Service Bulletin

SERVICE BULLETIN NO. 3
ENGINEERING ASPECTS ARE FAA APPROVED

SUBJECT: Aircraft-Engine Vibration Levels

Service Instruction No. 1452
Engineering Aspects are
FAA Approved

Figure 1. Bushing Indexing Configuration

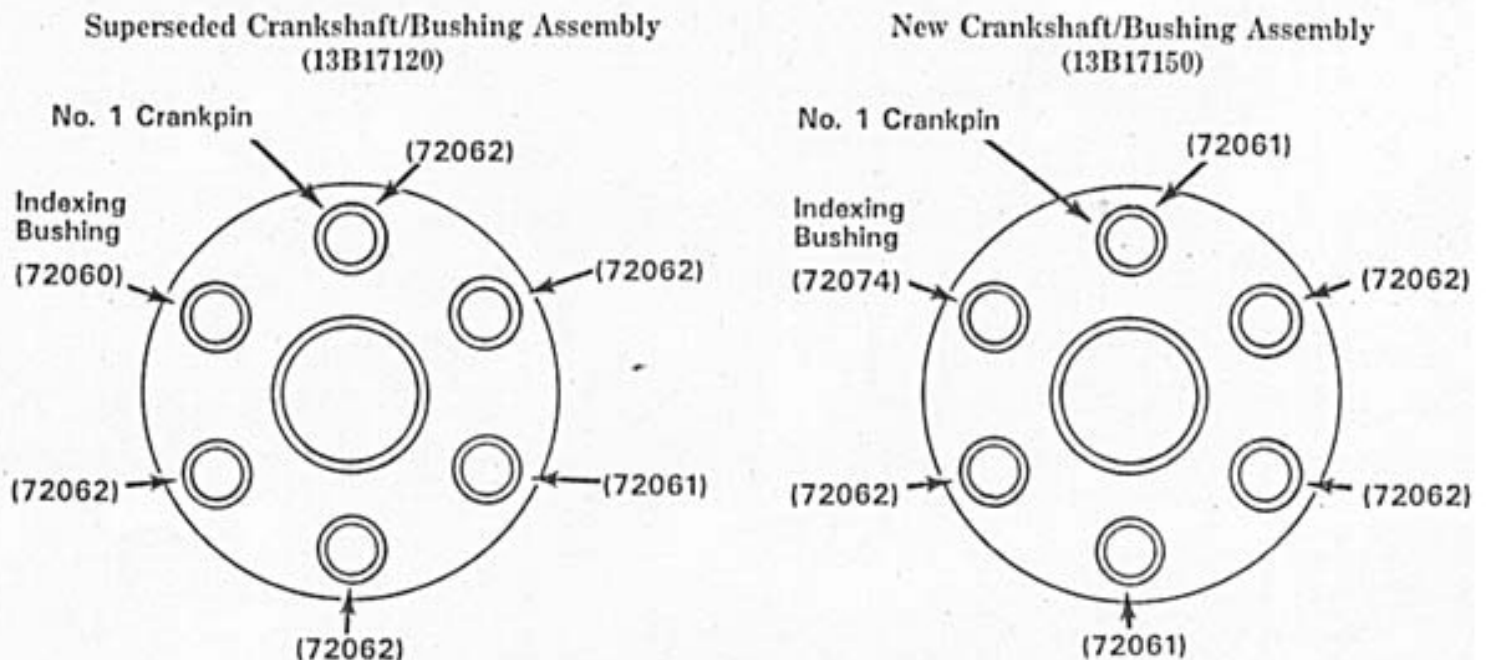
For the purpose of improving cabin vibration characteristics in Christen Husky aircraft employing the subject engine model, prop flange bushings are reindexed as shown in Figure 1. Refer to latest edition of Service Instruction No. 1098 for installation of replacement bushings. (Service-replacement bushings are designated with the suffix "S".)

Upon compliance with this Service Instruction, re-identify the new bushing configuration by vibropeening the new crankshaft/bushing assembly part number on the outside diameter of the prop flange. Note in log book.
